SERVICE BULLETIN

N° 139-630

**ATA 46 – COMPLETION OF KIT PRIMUS EPIC® PHASE 8 SOFTWARE RELEASE
INSTALLATION**

AW139 helicopter S/N 31869.

Figure 24

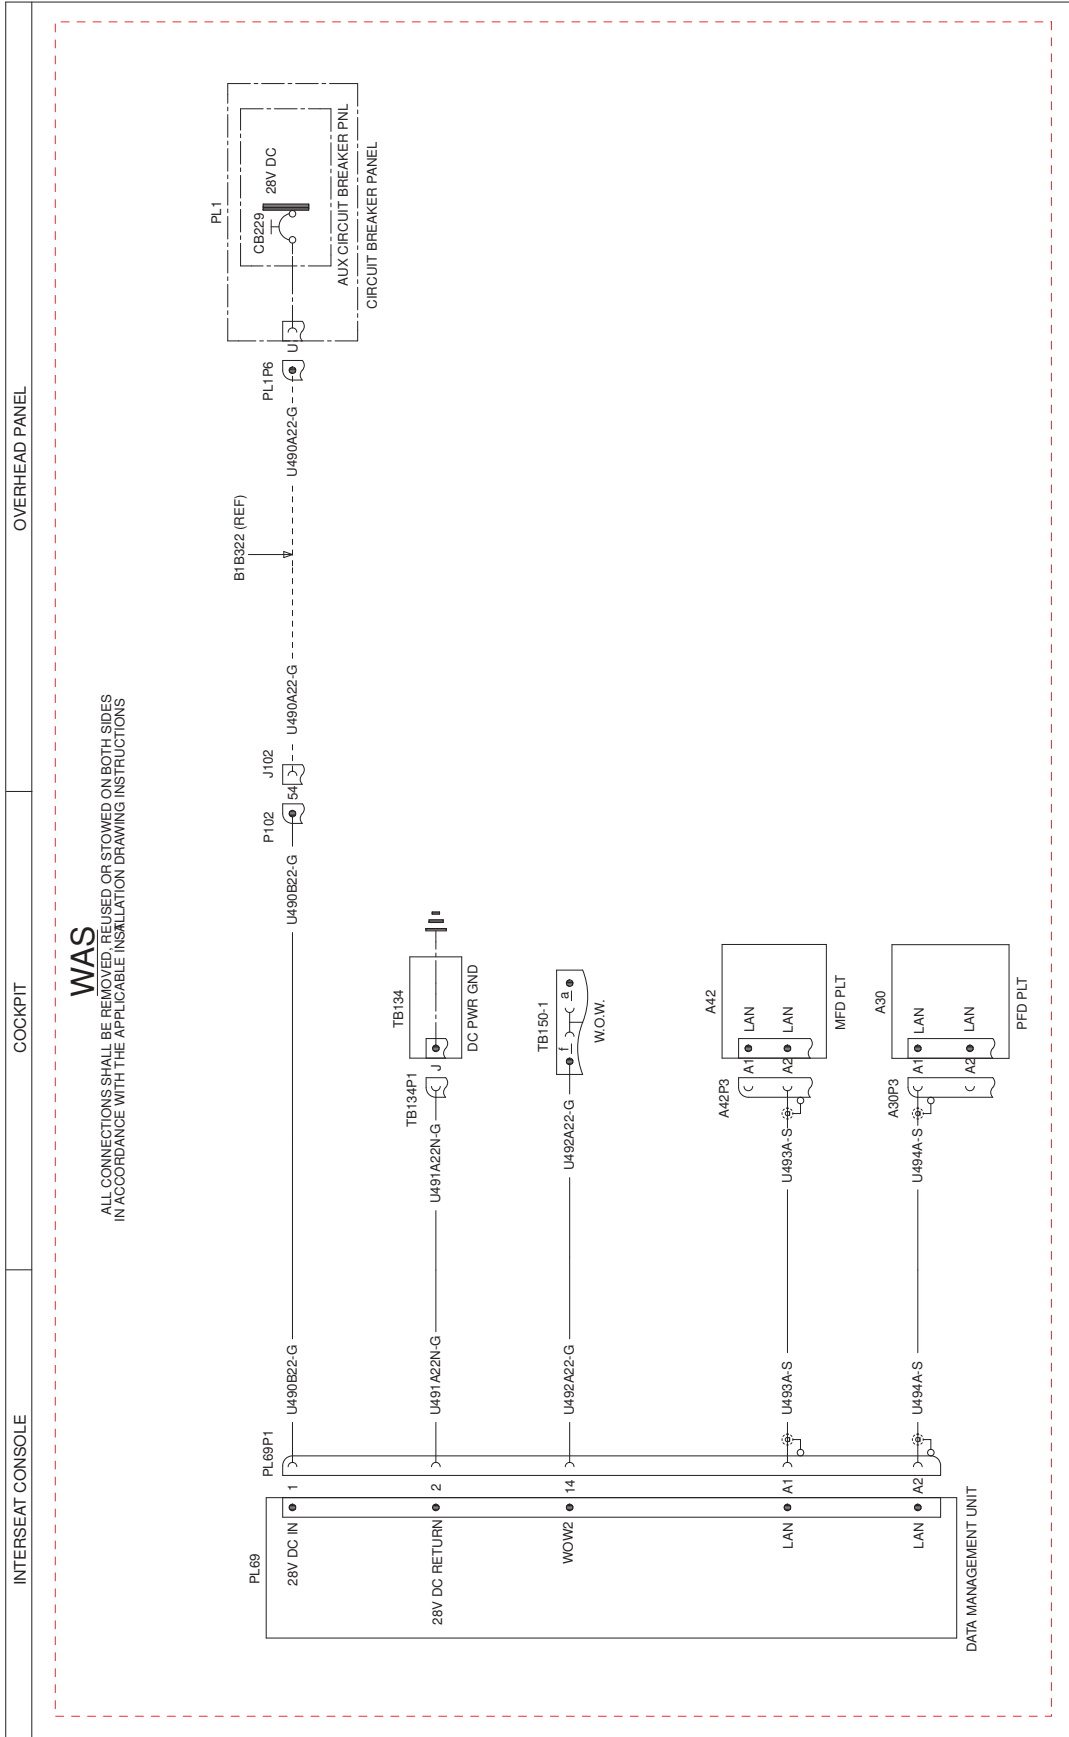
- 7.32 With reference to Figure 5 and Figure 24 wiring diagram, remove the electrical connections from MFD CPLT connector A95P3 as indicated and replaces as required. Use n°3 splices P/N M81824/1-1, n°7 electrical contacts P/N M39029/63-368 and wires P/N A556A-T24 as required. Mark wires as indicated by means of marker sleeves P/N A578A02-9.

- 7.33 With reference to Figure 5 and Figure 24 wiring diagram, remove the electrical connections from PFD CPLT connector A31P3 as indicated and replaces as required. Use n°3 splices P/N M81824/1-1, n°7 electrical contacts P/N M39029/63-368 and wires P/N A556A-T24 as required. Mark wires as indicated by means of marker sleeves P/N A578A02-9.

Figure 29

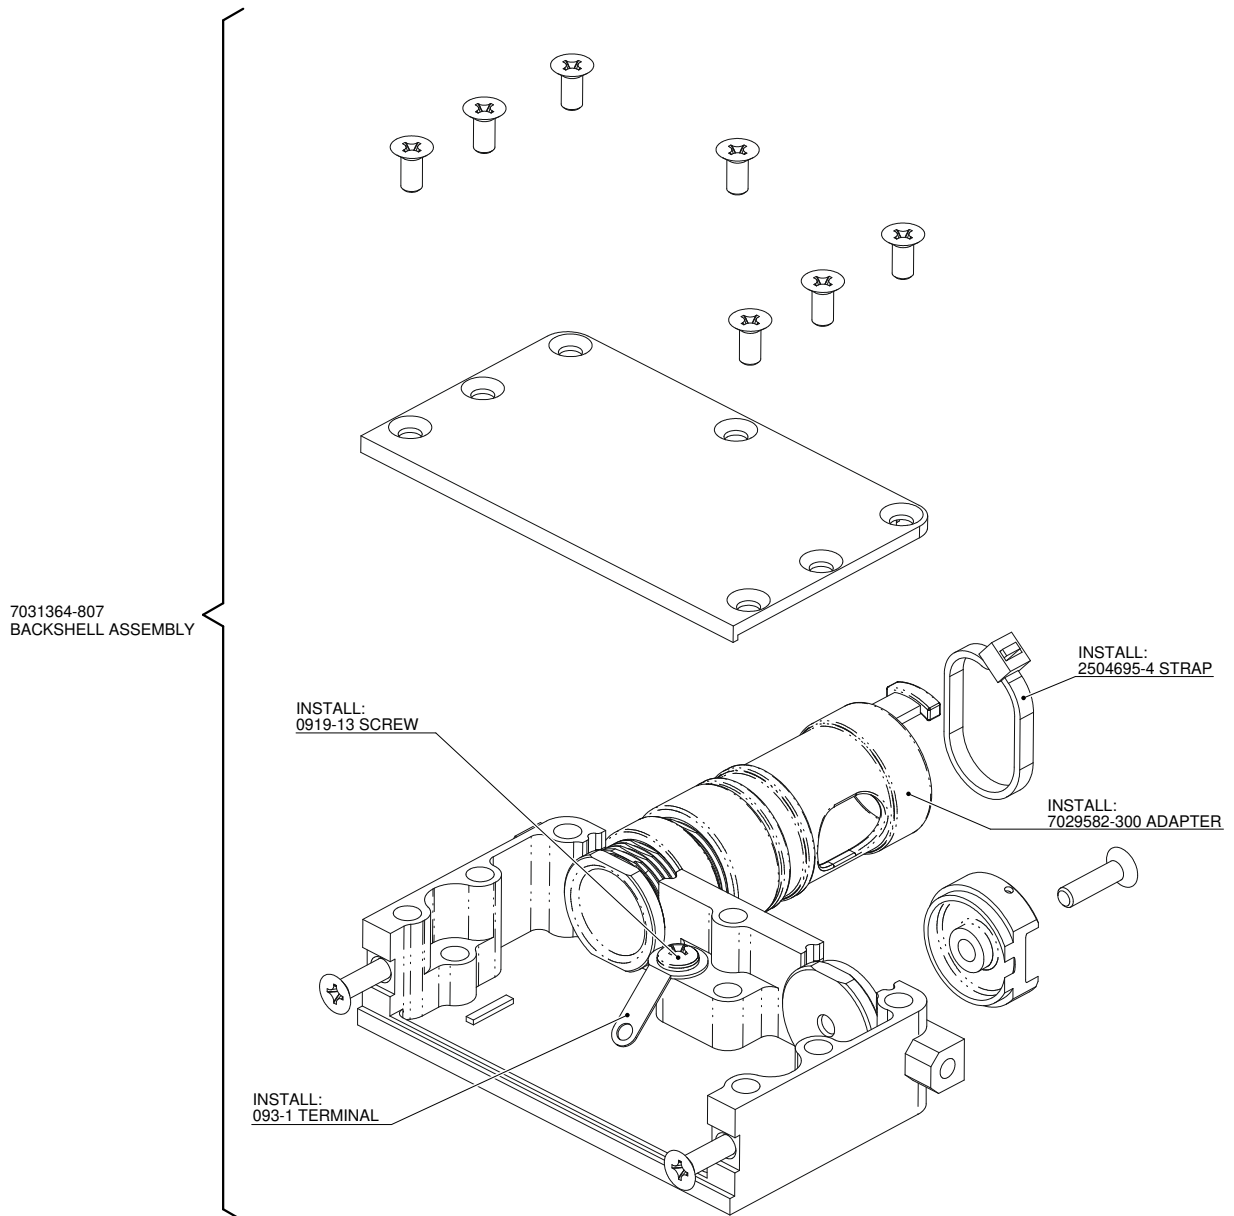
- 7.18 With reference to Figure 4, remove n°2 backshells P/N 7031364-806 and replace with n°2 backshells P/N 7031364-807.
- 7.19 With reference to Figure 29, rework n°2 backshells P/N 7031364-807 by means of n°2 screw P/N 0919-13, n°2 terminal P/N 093-1, n°2 strap P/N 2504695-4 and n°2 adapter P/N 7029582-300.

- 7.24 With reference to Figure 29, rework n°2 backshells P/N 7031364-807 by means of n°2 screw P/N 0919-13, n°2 terminal P/N 093-1, n°2 strap P/N 2504695-4 and n°2 adapter P/N 7029582-300.
